Minutes of Extraordinary Planning Meeting

3) Application(s) reference: 19/01235/FUL

Proposed: Creation of a vehicular access for agriculture/forestry maintenance of the land including the creation of a new private footpath/bridleway running along the vehicular access.

PLANNING APPLICATION 19/01235/FUL

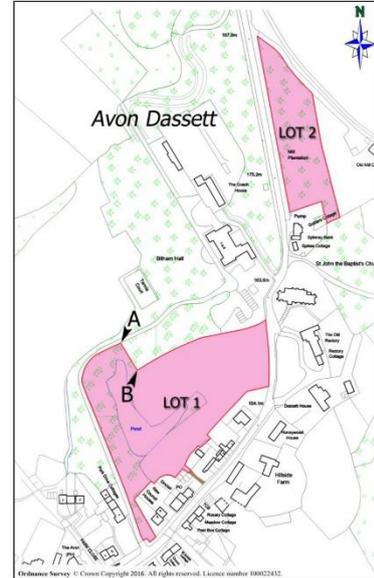
2. The Applicant has stated that there is no existing vehicular or pedestrian access to the site. This is quite clearly incorrect as within the "Blue Land" confirmed as owned by the Applicant there is an existing vehicular access to the south of 4 Hill View with a 3.7 m wide field gate as shown on the attached sales particulars for the site (Appendix A). There is also a newly constructed pedestrian access just to the north of the listed Bitham Hall driveway. Originally there was also a further, now unused, access off the Bitham Hall driveway to the north of the site. The existing access points have been adequate to date and it is therefore not unreasonable to ask the question what has changed and now requires a new 5m wide vehicular access for agricultural and forestry maintenance.

BLOCK PLAN
D NEW FOOTPATH / BRIDLEWAY AND PROPOSED NEW AGRICULTURAL / FORESTRY MAIN
LAND TO THE REAR OF THE OLD SCHOOL, AVON DASSETT, SOUTHAM. CV47 2AH

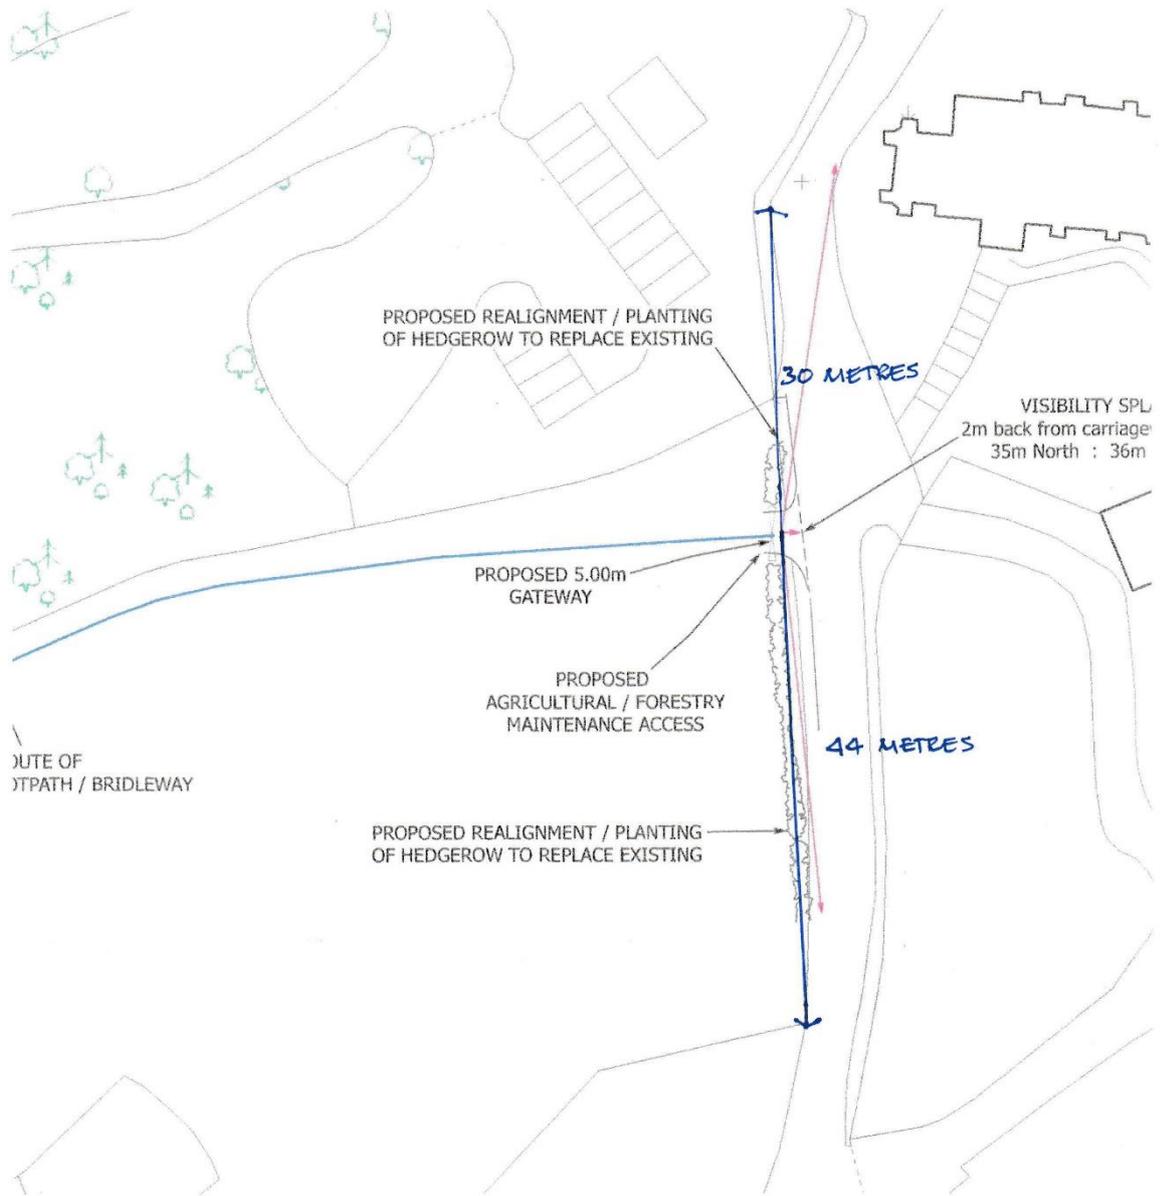
3. Regarding the new access, the details provided are to such a small scale that they can only be considered diagrammatic. The relevant guidance is contained in Development Control Advice Note 15 for Vehicle Access Standards. I am not an expert in highways design and no doubt the relevant Highways authority will be commenting in due course, however, I have attempted to interpolate the guidance. The Applicant has indicated a vision splay of $X = 2m$ measured back from the edge of the road where traffic speeds are less than 37mph with a Y dimension of $Y = 35/36m$ whereas DCA Note 15 the Y dimension should be **66m** measured along the near edge of the main road from the centre of the access road with a forward vision of 33m for vehicles using the main road. The Applicant's land only extends to some 44 metres to the south therefore the 66m vision splay cannot be achieved. (Appendix B).

The vision splay proposed by the Applicant to the north is incorrectly drawn. From the attached extract from DCAN 15 (Appendix C) it clearly indicates that the vision splay to the north should be tangential to the curve of the road. However, the wall in the south east corner of the Bitham Hall land would reduce the Y dimension to some 30m. The indicated vision splays also do not take into account the proposed location of the access directly opposite an existing driveway, on a steep hill, close to a sharp bend and on a road, which is only 4.2 metres wide at that point (Not 4.5m as shown on the Applicant's drawings). Any farm maintenance vehicles exiting the site would inevitably be crossing the entire width of the road. The drawings provided are inaccurate as they seem to imply that the main carriageway widens at the entrance to the Old Rectory and outside the steps of St John's Church where there is in fact a grass bank (See attached photographs Appendix D).

4. As previously mentioned, the drawings are based on small scale OS maps with no detail of the existing hedgerow or the trees along the hedgerow. The advisory note on making a planning application suggests that drawings should be at a minimum scale of 1:200 at A3 not 1:500 as presented. If the correct depth of vision splay was adopted this would potentially mean that much of the existing hedgerow and at least one mature tree (see attached Appendix D) would have to be removed to facilitate the access and the vision splay to the north would be curtailed by the wall on the south east corner of Bitham Hall. Existing electricity poles would potentially have to be relocated.

5. The potential dangers associated with the proposed location of the access road are further exacerbated by the fact that there is no footpath on the western side of the main road north of the proposed access until the point where the Bitham Hall wall commences. The footpath on the east side of the road terminates outside the Old Rectory causing those walking up the hill to cross the road on a blind bend right by the proposed access road. The plan DAJ/71129 B(ii)gn shows a distinct lack of knowledge of the local footpath network whereby the northern footpath link from the proposed new access is shown on the right-hand side of the main road.
